# TECHNICAL INFORMATION AND SERVICE DATA SHEET

**AWA RADIOLA**

**Model 564-GA**

TO BE READ IN CONJUNCTION WITH  
SERVICE MANUAL FOR MODEL 550-GA.

## Circuit Changes:

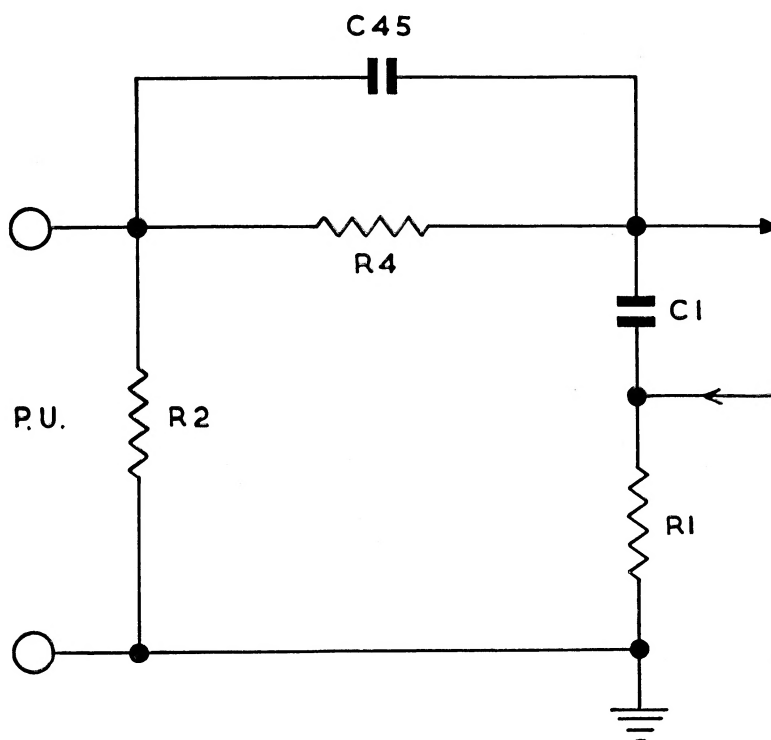
- (1) Capacitor C37 changed to 0.005 paper 600V working.
- (2) Resistor R4 is paralleled with C45 — 1000  $\mu\mu\text{F}$  mica.
